CNL-14-007

Watts Bar Nuclear Plant, Unit 1
Facility Operating License No. NPF-90
NRC Docket No. 50-390

Subject: Follow-up Response to NRC Request for Additional Information Related to Overall Integrated Plan in Response to the Commission Order Modifying Licenses with Regard to Requirements for Reliable Spent Fuel Pool Instrumentation (Order Number EA-12-051) (TAC Nos. MF0951 and MF1178)

Sketch 1

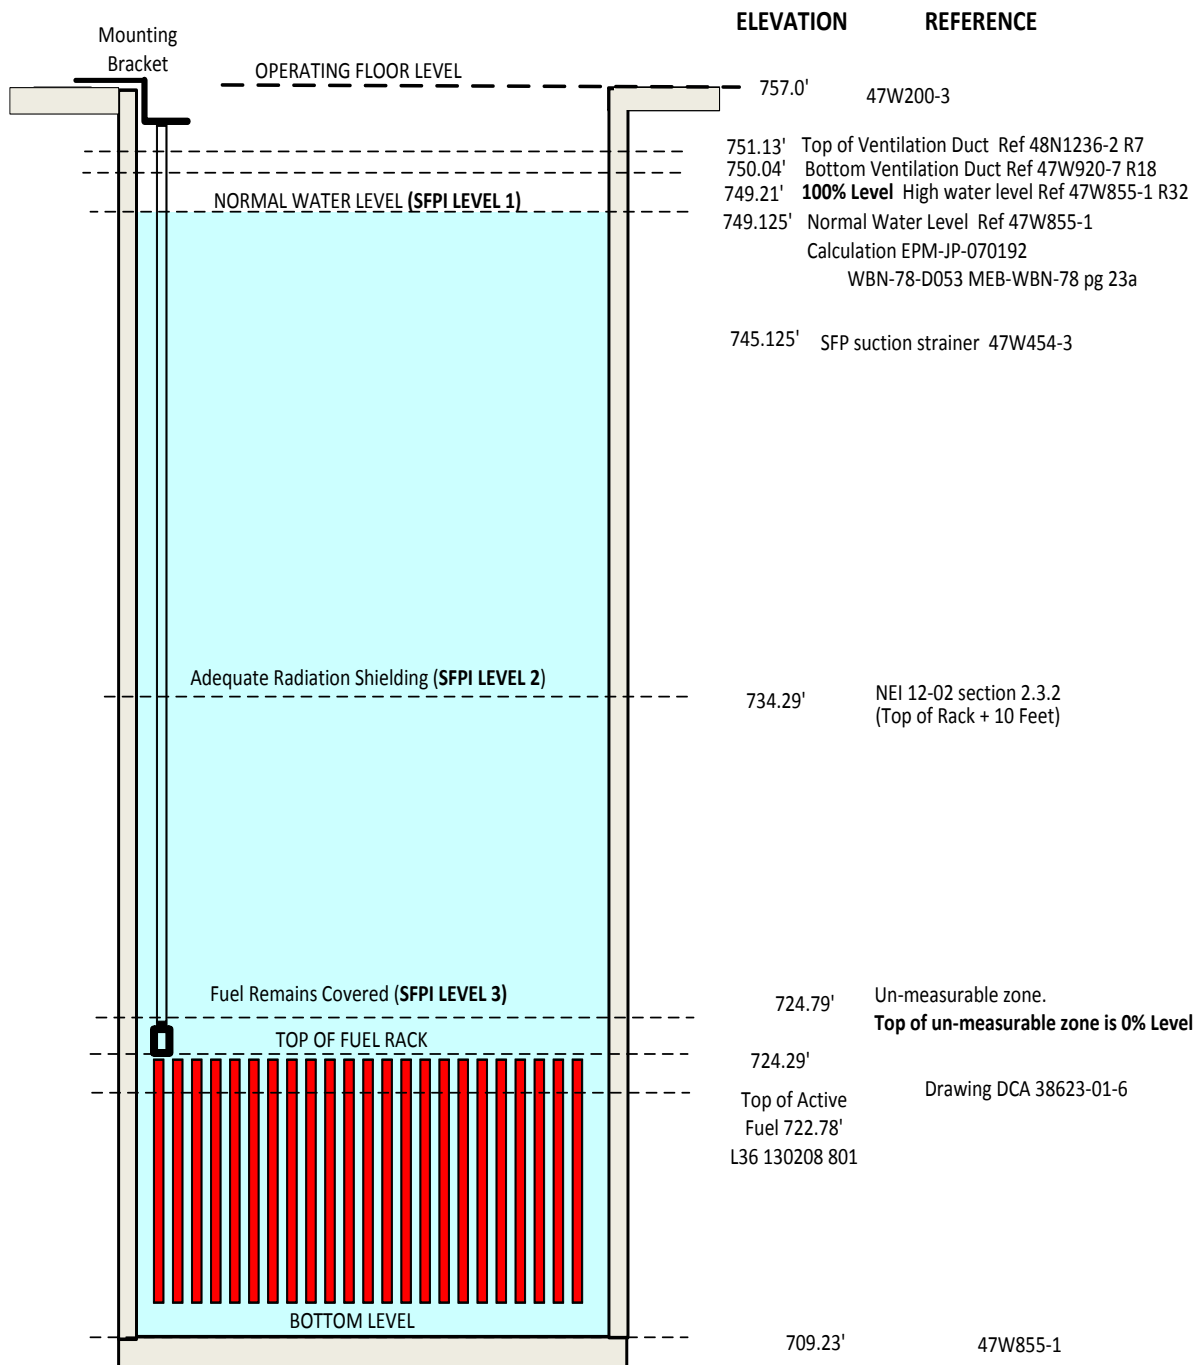
During the December 19, 2013, teleconference call, clarification was requested regarding throttling of pump discharge as discussed in response to RAI question 1. Information has been added to the response as underlined below to address this clarification. Sketch 1 has also been revised to include the top and bottom vent elevations as shown. This revised response and Sketch 1 supersede those submitted in the referenced letter.

Please provide the results of the calculation used to determine the water elevation necessary for the pump's required NPSH to confirm that Level 1 has been adequately identified.

Watts Bar Nuclear Plant (WBN) calculation EPM-JPJ-07-192 documents adequate net positive suction head (NPSH) at elevation 749.125 feet (normal pool level) for Spent Fuel Pool (SFP) temperatures up to 190 degrees Fahrenheit (F). Refer to Sketch 3 on page E1-23. During a BDB-EE, as temperatures rise above 190 degrees F, WBN will control by procedure the throttling of pump discharge to ensure adequate NPSH. The calculation detailing this throttling requirement for BDB-EE has not been issued at this time. WBN has documented this action in the Corrective Action Program Problem Evaluation Report (PER) 770244 and the scheduled completion of calculation and procedure update is by February 21, 2014. Throttling is required because the level 1 reference elevation cannot be raised to provide adequate NPSH above 190 degrees F since ventilation ductwork is approximately 0.8 feet (elevation 750.04 feet) above the existing 100% level (refer to Sketch 1). Access to SFP pumps, heat exchangers, and valves can be achieved from the Shutdown Board Room, shown in sketch 1, on elevation 757 through the Auxiliary Building access point and down the central stairway to elevation 737 or from the Auxiliary Building access point on elevation 713 and up the north or central stairway to elevation 737. Valves that would require manipulation based on which train of SFP cooling is being restored are located in the center south area of elevation 737.
